**MANDATORY SERVICE BULLETIN NO.**  
**MSB 40-103 / MSB F4-042 / MSB D4-114 / MSB 40NG-084**  
**REV. 2**

**SUPERSEDES MSB 40-103 / MSB F4-042 / MSB D4-114 / MSB 40NG-084**  
**REV. 1**

Actions to prevent Passenger Door Separation: Installation of Placards, AFM Procedure update and Inspection/Data Gathering.

**WORK INSTRUCTION**  
**WI-MSB 40-103 / WI-MSB F4-042 / WI-MSB D4-114 / WI-MSB 40NG-084**  
**REV. 2**

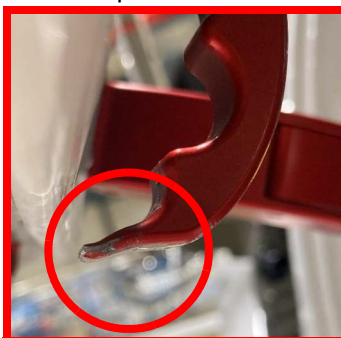
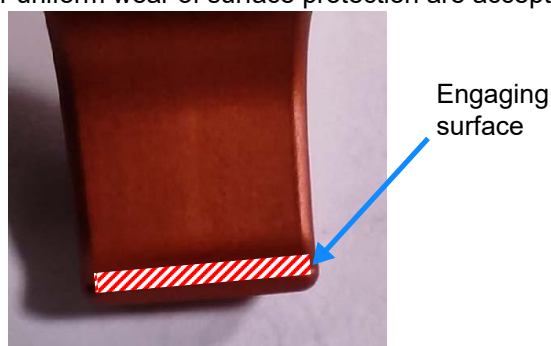
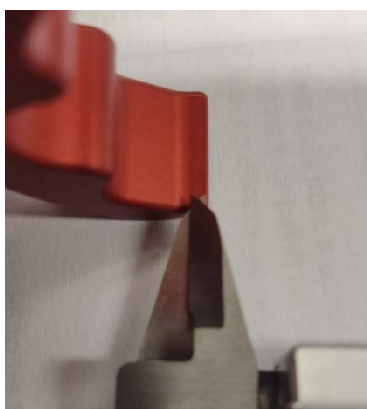
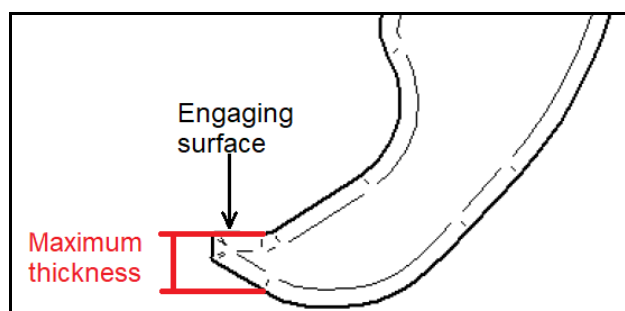
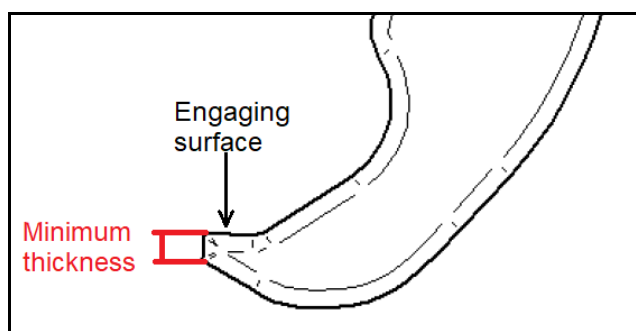
5. Examine the safety hook for signs of wear, corrosion and poor condition:  
Record the condition of the hook on the execution report in Appendix A.

- a) Check the contact area of the push button.
- Grooves in the safety hook must be less than 2 mm deep.

- c) Examine the tip of the safety hook for wear:
- Wear of edges of safety hook.
  - The width of the tip of the safety hook must be greater than 10.5mm.

- d) Examine the engaging surface of the safety hook, which is the plane surface at the tip of the safety hook.
- It must not have any steps and ridges.
  - Scratches or uniform wear of surface protection are acceptable.

- e) Measure the width of the engaging surface.
- The width must be greater than 1.5 mm.

- f) Measure the maximum thickness of the safety hook at the location of the engaging surface, perpendicular to the engaging surface.
- The maximum thickness must be greater than 2.5 mm.
  - The variation of thickness measured along the width of the safety hook must be less than 0.2 mm.

- g) Measure the minimum thickness of the safety hook at the location of the engaging surface, perpendicular to the engaging surface.
- The minimum thickness must be greater than 1.5 mm.
  - The variation of thickness measured along the width of the safety hook must be less than 0.2 mm.

- h) If the safety hook does not meet one or more of the acceptable conditions listed above on sub-steps **a** through **g**, take note to replace the safety hook after this WI is completed. Refer to Section IV for replacement of the safety hook.

Figure 2.

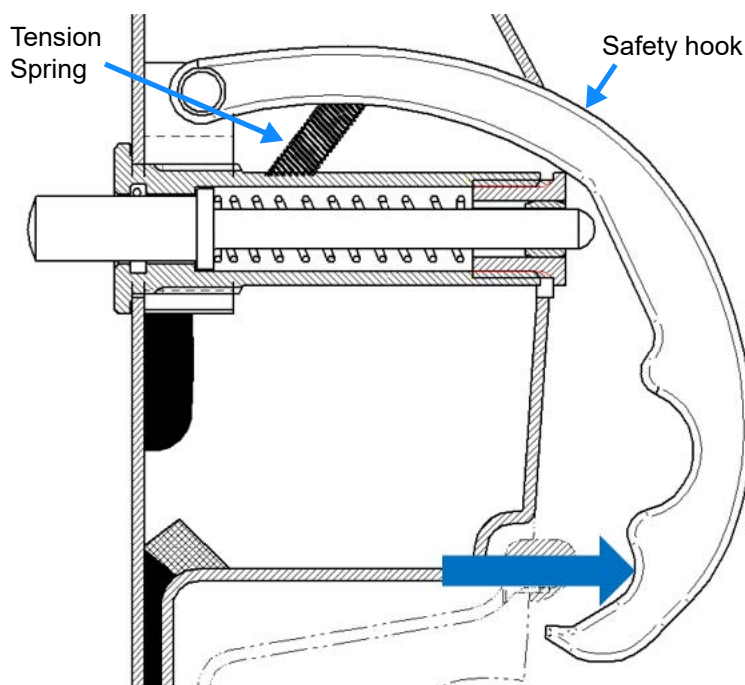
6. Check the condition of the tension spring and the force to lift the safety hook from its resting position as follows:  
Refer to Figure 2.
- Open the passenger door.

- Examine the tension spring of the safety hook. Use a borescope through cutout in the door, if corrosion, deformation or damage is found, take note and replace it after this WI is completed. Refer to Section IV for removal and installation of the hook assembly.

- Lift the safety hook and release it.
    - After releasing the force, the safety hook must snap back into its resting position.
    - If the safety hook does not snap back into its resting position, do the following:

- Check the attachment of the safety hook for increased friction.
      - Check for interferences in the range of motion of the safety hook.
      - Record findings on the execution report in Appendix A.

- If correction/replacement of any part is required, take notes and do it after this WI is completed. Refer to Section IV for removal and installation of the hook assembly.

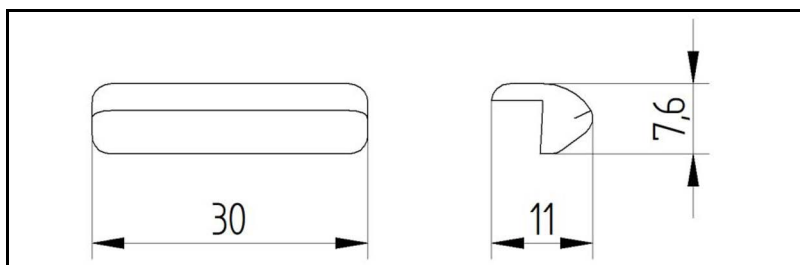
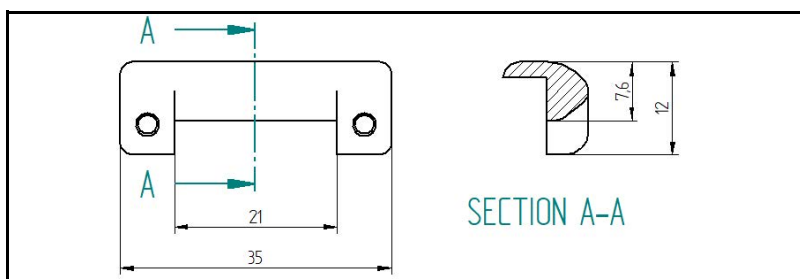
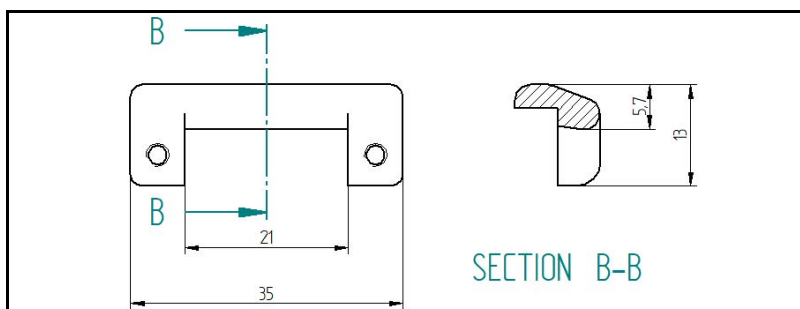
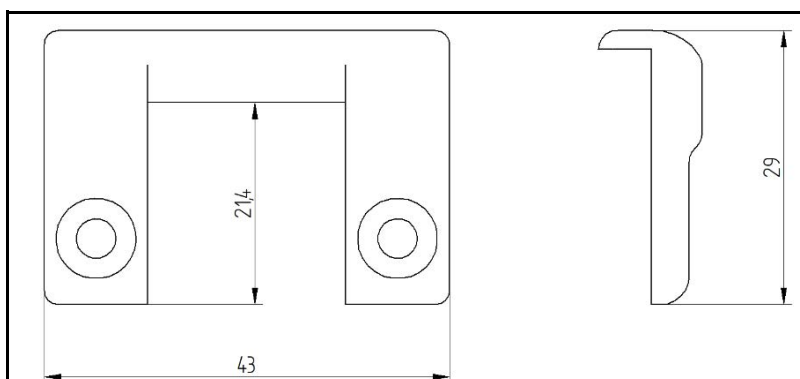
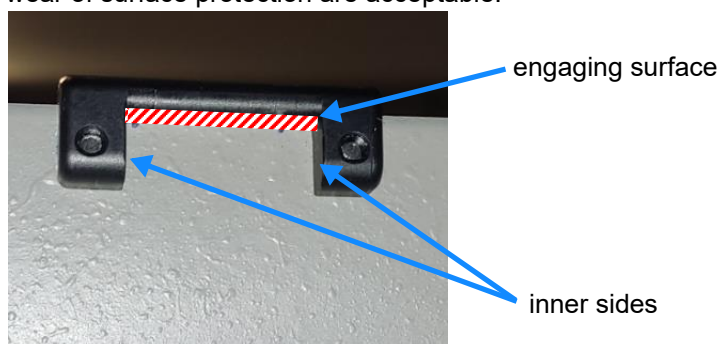
7. Identify the version of the retaining block:  
Record the version in the execution report.

Small (DA4-5200-00-69)

Extended without undercut (DA4-5200-00-69\_1)

Extended with undercut (DA4-5200-00-69\_02)

Long extended (DA4-5200-00-69-SB)

Figure 4.

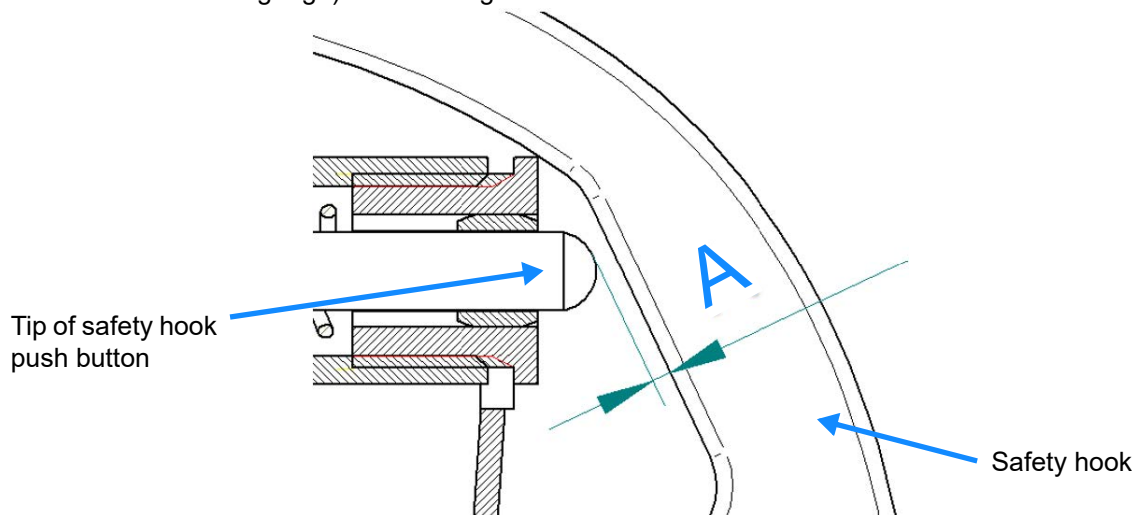
- Dimension A: distance of push button to the safety hook in resting position (e.g. with a feeler gauge). Refer to Figure 4.

Figure 5.

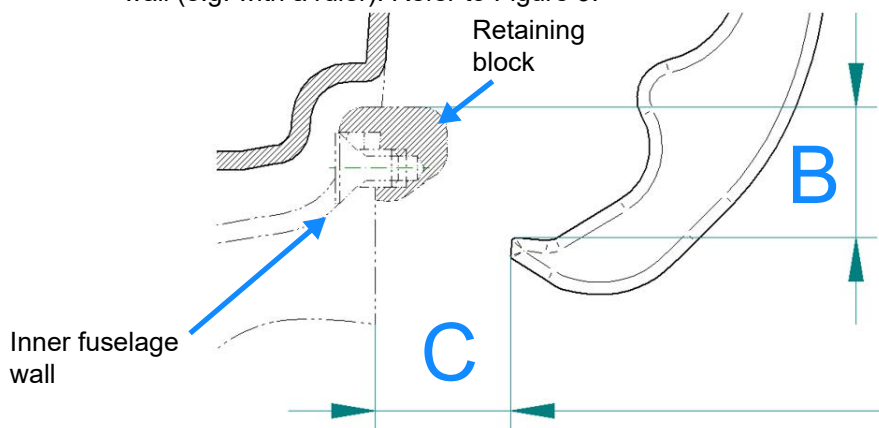
- Dimension B: distance between the top surface of the retaining block to the top surface of the engaging section of the safety hook in resting position (e.g. with a ruler). Refer to Figure 5.
- Dimension C: horizontal distance between the tip of the safety hook and the fuselage wall (e.g. with a ruler). Refer to Figure 9.

Figure 6.

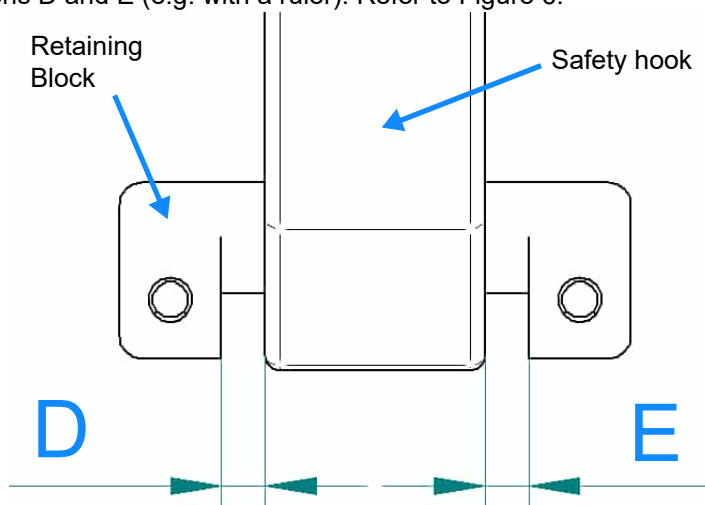
- c) Unlatch the passenger door and push the passenger door open, engaging the safety hook into the retaining block. Apply slight pressure to the passenger door to keep the safety hook engaged during the measurement.
- d) Record the measurements on the execution report in Appendix A.

- Dimensions D and E (e.g. with a ruler). Refer to Figure 6.

Figure 10.

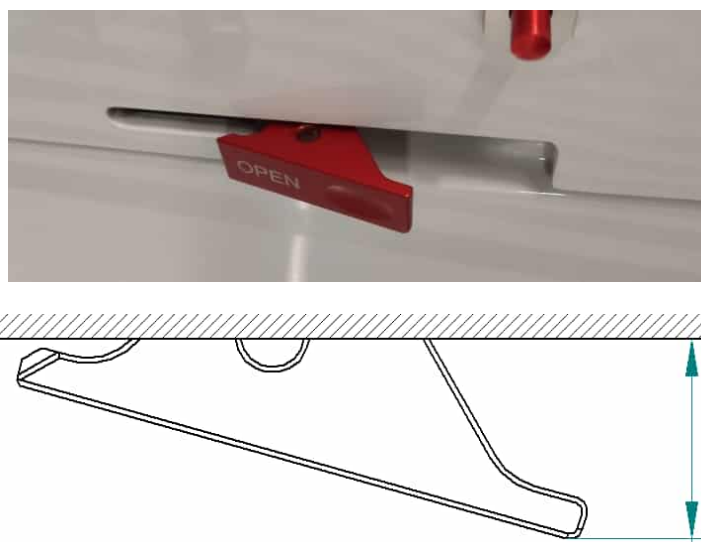
15. If the old passenger door latch is installed (refer to step 14), visually inspect the spring:  
Refer to Figure 10.
- a) Move the passenger door handle to the unlatched position.
  - b) Visually inspect the spring.
    - Look specifically for a broken winding, replace the spring if found broken.
  - c) Record any findings on the execution report in Appendix A.

Figure 11. Protrusion measurement

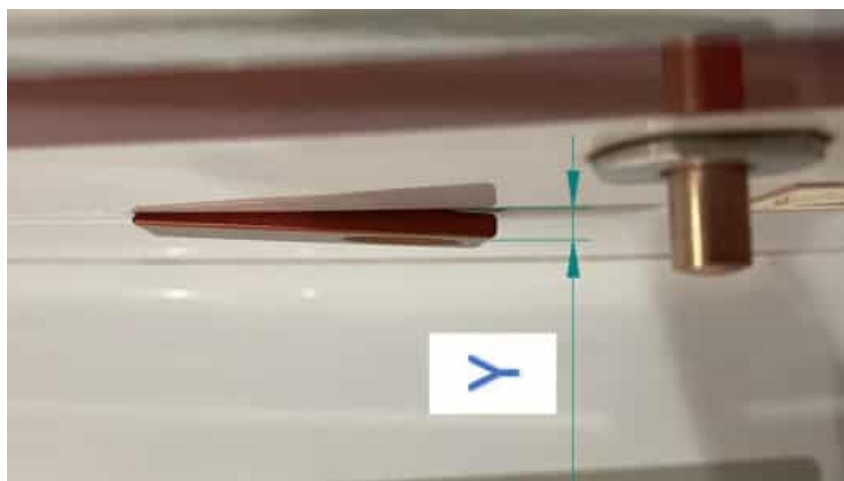
19. Data collection: Position of the external passenger door handle. Refer to Figures 11 and 12.

- a) Close the passenger door.
- b) Push the external passenger door handle into the latched position until it stops.
- c) Examine if the passenger door handle is recessed, flush or protruding over the passenger door surface.
- d) Record the condition of the passenger door handle on the execution report in Appendix A.
- e) If the handle protrudes from the surface of the passenger door, measure the protrusion.
- f) Record the measurement on the execution report in Appendix A.

Figure 18. Example of **NOT** acceptable condition of door guide block

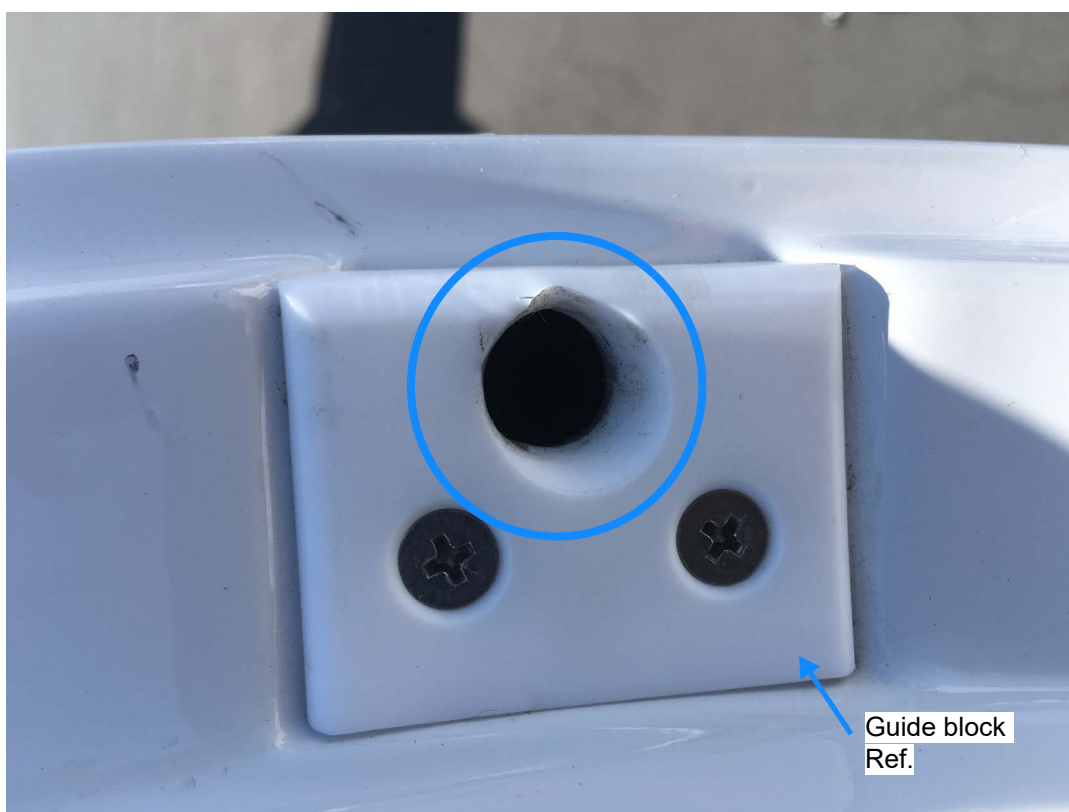
23. Inspect the front and rear door guide block for damage. Refer to Figure 18.

- a) Open the passenger door.
- b) Visually check the condition of the guide block.
  - The guide block must not have worn edges, dents, cracks.
  - If you found any damage, take note and replace the guide block after the WI is completed. Refer to section IV for the replacement.
  - Record any damage of the guide blocks on the execution report in Appendix A.

Figure 29.

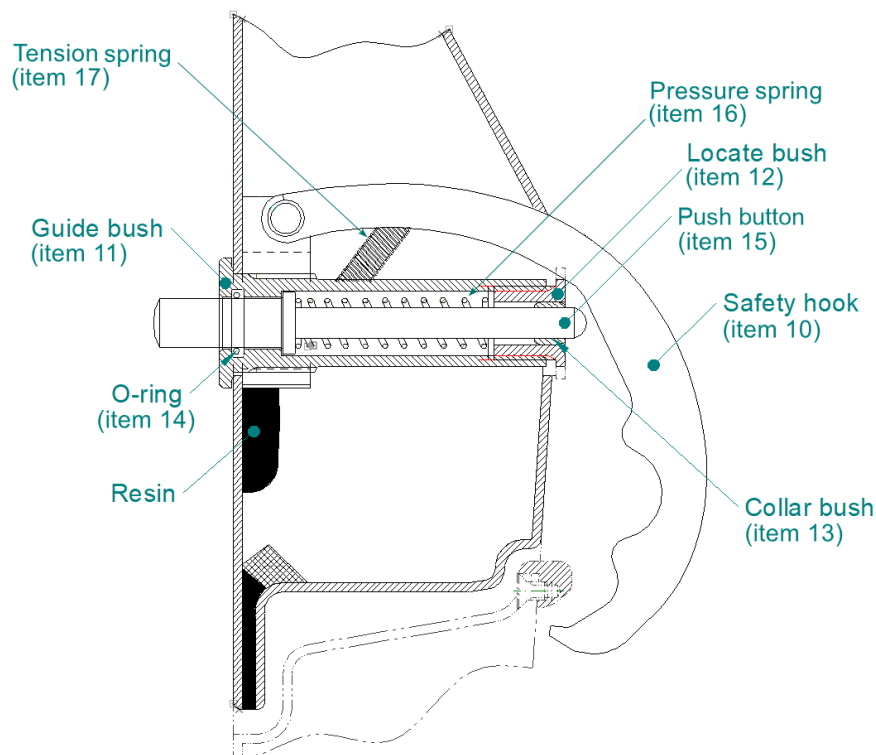
Refer to Figure 29.

NOTE: To replace the safety hook or push button, the hook assembly (safety hook and push button) needs to be removed from the airplane and taken to a work table for disassembly.

1. Remove the inner door handle to get access to the inside of the door. Refer to AMM Section 52-10.
2. Unscrew the guide bush and locate bush to release the push button assembly.

3. Remove the hook assembly from aircraft through the handle opening and place it on a work table to replace safety hook.
4. Remove screw that secures the tension spring on the safety hook.
5. Remove cotter pin to release safety hook, pin and washers.
6. Install the new safety hook (item 10) using the pin, washers and cotter pin.
7. Reinstall tension spring using the screw to secure it. Use Loctite 262 (item 6) to screw, refer to manufacturer instructions for proper use.

8. Replace any defective parts of the push button.
9. Reinstall hook assembly to the aircraft door:
  - a) Route the hook assembly through the handle opening and secure to outside door shell with guide bush (item 11).
  - b) Insert collar bush (item 13) into locate bush (item 12).
  - c) Apply a small amount of Vaseline (item 8) to o-ring (item 14) and insert into guide bush.
  - d) Insert push button (item 15) and pressure spring (item 16) into guide bush (item 11) and screw guide bush and locate bush (item 12) together.
  - e) Apply ITW Plexus MA300 (item 9) or thickened resin (5 min epoxy + cotton flakes) to the bearing block on the inside of the door. Refer to Figure 30 and the manufacturer instructions for proper use.
10. Record the replacement on the execution report in Appendix A.

Figure 31.

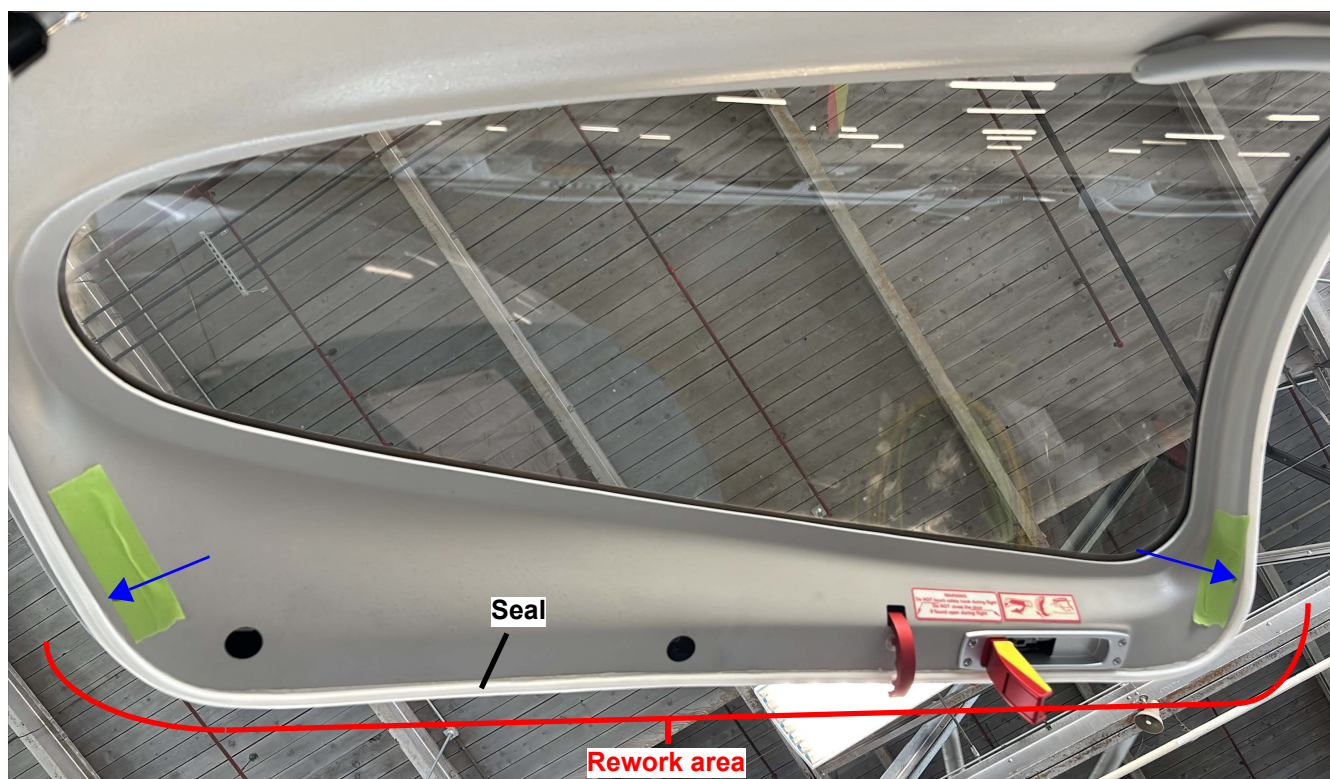
1. Carefully remove the door seal from the door only in the rework area specified in Figure 31. Be careful not to damage the seal during removal. Leave the seal hanging.
2. If required, remove existing sealant from the area where you removed the seal and clean the surface for the new sealant.
3. Apply 0-5 mm bead of clear silicone sealant (item 23) to the door.
4. Reinstall seal and allow sealant to cure. Refer to sealant manufacturers instructions.
5. Repeat step 20.c). and check if the force is between 2 kg (20 N) and 6 kg (60 N).
  - If the force is below 2 kg (20 N): Reapply sealant up to maximum allowed and repeat test. If test cannot be passed, replace gas spring.
  - If force is above 6 kg (60 N): Remove sealant, apply a thinner layer of sealant and repeat test.
